SUBJECT: CLARFICATION FOR DE00093, W-5205V, ROADWAY IMPROVEMENTS

AT THE INTERSECTION OF SR 1106 (BARBEE RD) AND SR 1105/SR 1104 (HERNDON RD) IN DURHAM COUNTY, WBS ELEMENT: 45335.3.FD23

## MEMORANDUM TO PROSPECTIVE BIDDERS

UC-3, Water Relocation Details

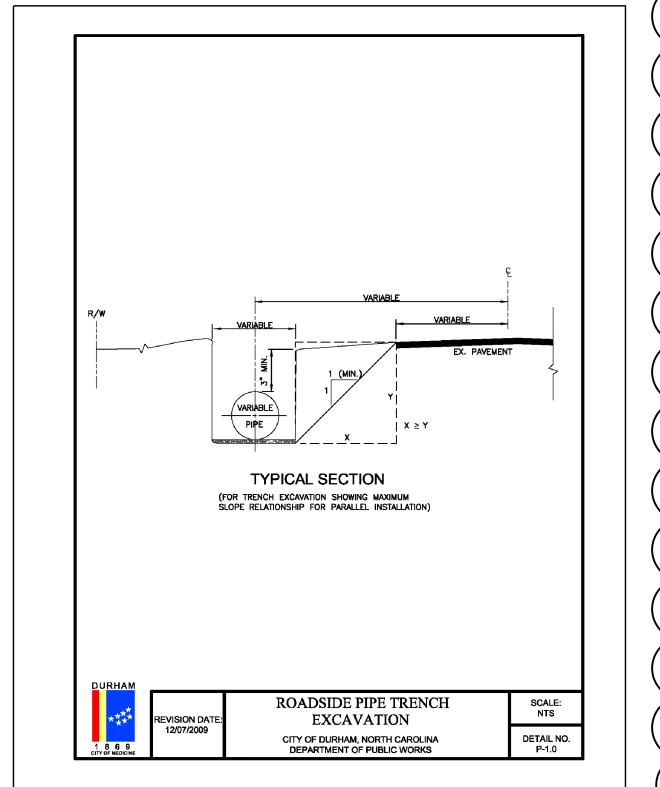
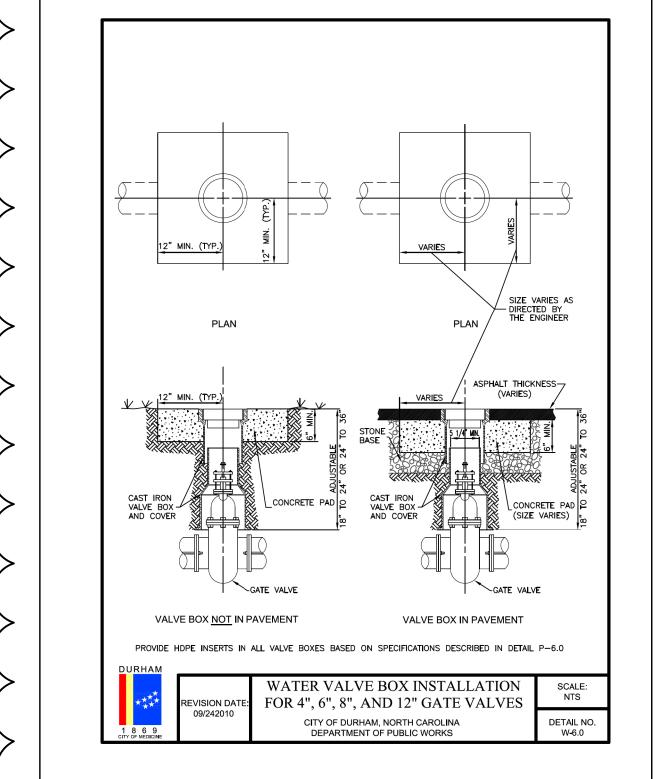
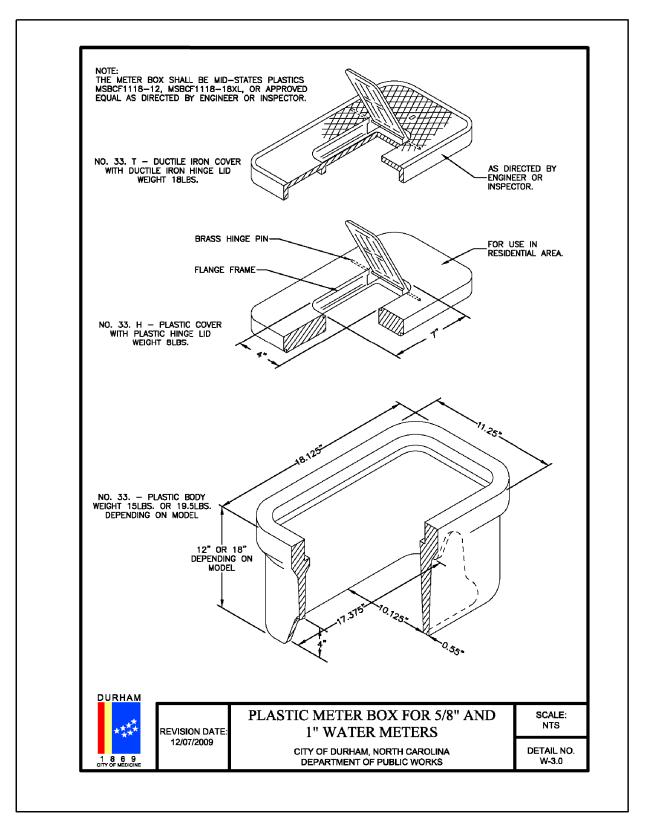
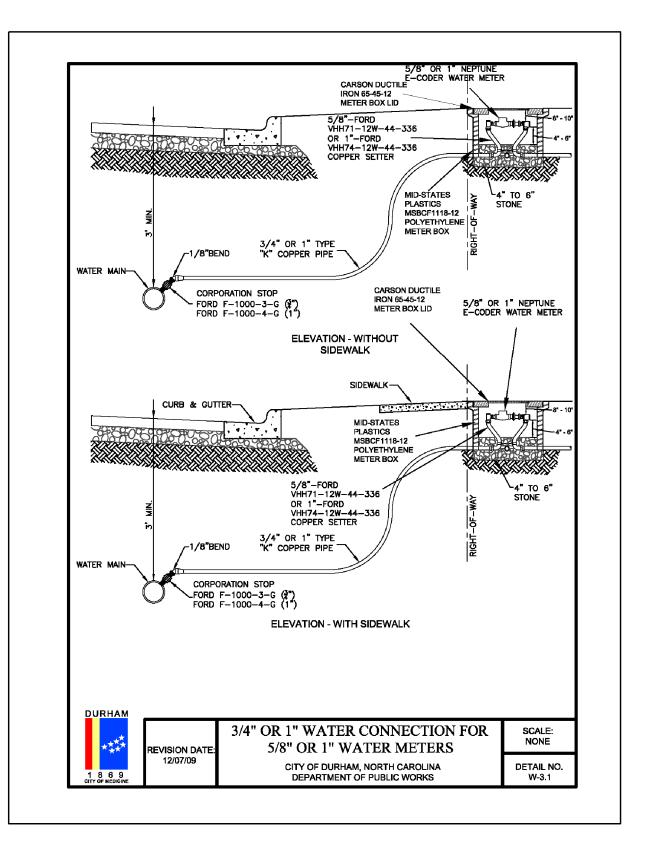
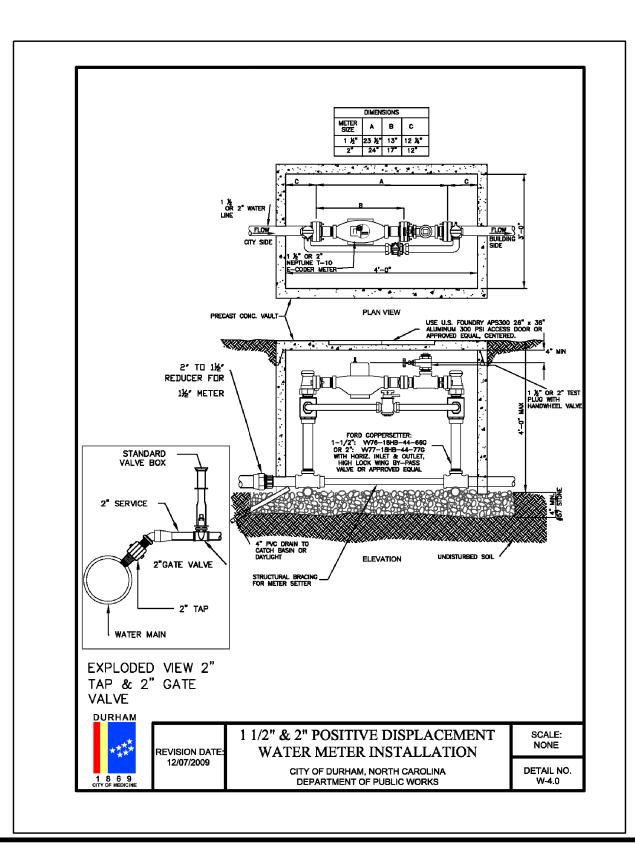
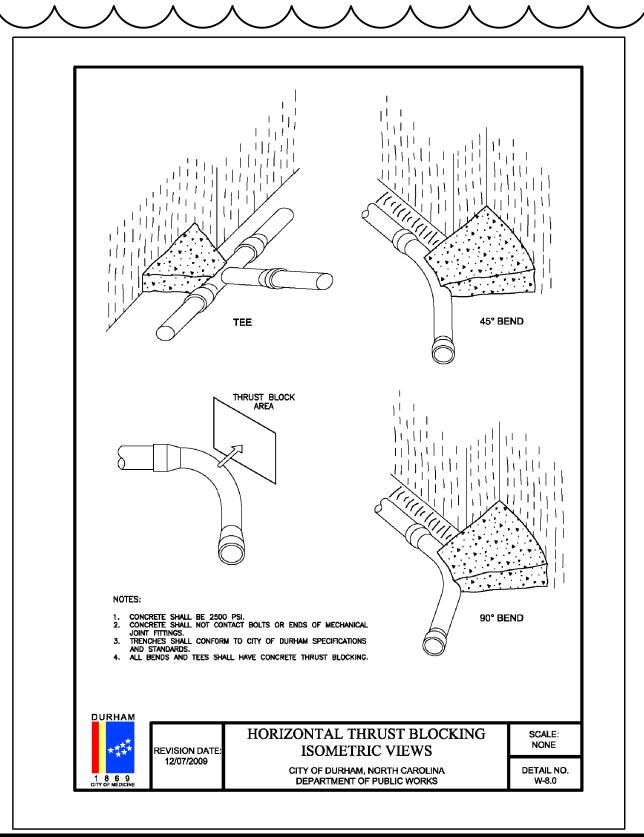
This letter is being issued to clarify an item on the subject project. The following plan sheet on project W-5205V inadvertently had the wrong valve detail included. The detail sheet has been revised and the new plan sheet is attached:

REPLACED TS%L VALVE GATE VALVE DETAIL 5
